Access Compliance Report

Public Rights-of-Way

(Curb Ramps)

Intersection ID: N/A	Main Street: COSTIGAN_LN	Cross Street: N/A	Location: S
ADA ID: BD3B2BE51608	Ramp Type: PerpDiag	Initial Pass/Fail: Fail	Overall Compliance: No
Severity Score: 21.25			
Codes/Mitigation Info/Possible Solution		Field Measurements/Component Compliance

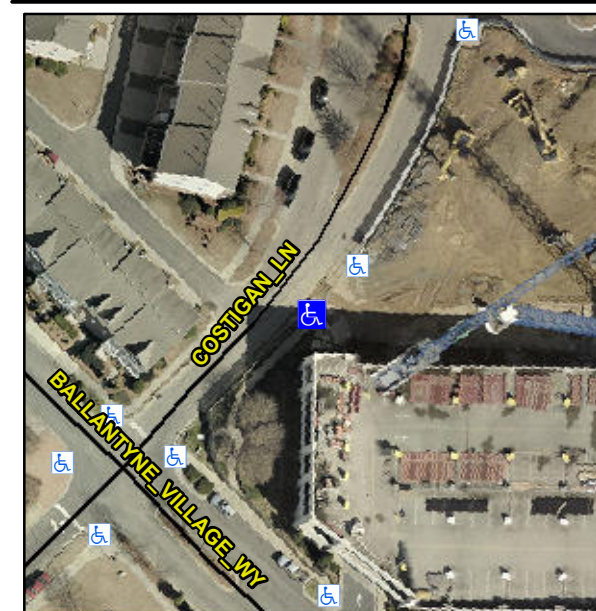
Not Found, R304.5.1, R304.5.3

Compliance	Description	Data	Compliance	Description	Data
N/A	Ramp Length (in)	74.0	Yes	Ramp Slope (%)	5.0
No	Ramp Width (in)	40.0	No	Ramp XSlope (%)	6.0
N/A	Flare Type LT	N/A	N/A	Flare Type RT	N/A
N/A	Flare Slope LT (%)	N/A	N/A	Flare Slope RT (%)	N/A
N/A	Flare Traversable LT?	N/A	N/A	Flare Traversable RT?	N/A
N/A	Landing Length (in)	N/A	N/A	DWS Provided?	N/A
N/A	Landing Width (in)	N/A	N/A	DWS Contrast?	N/A
N/A	Landing Slope (%)	N/A	N/A	DWS Length (in)	N/A
N/A	Landing X Slope (%)	N/A	N/A	DWS Full Width?	N/A
N/A	Landing Curb? (Y/N)	N/A	N/A	DWS Offset (in)	N/A
N/A	Shared Landing?	N/A			
N/A	Gutter Ponding?	N/A	N/A	Gutter Slope (%)	N/A
N/A	Gutter Lip Ht (in)	N/A	N/A	Gutter X Slope (%)	N/A
N/A	Painted X Walk1?	No	N/A	Painted X Walk2?	No
	X Walk 1 Direction	To NE		X Walk 2 Direction	To NW
N/A	X Walk 1 Width (in)	N/A	N/A	X Walk 2 Width (in)	N/A
	X Walk 1 Slope (%)	1.2		X Walk 2 Slope (%)	3.9
	X Walk 1 X Slope (%)	5.4		X Walk 2 X Slope (%)	1.7

Remove & Replace Curb Ramp With Two New Directional Ramps or Equivalent.
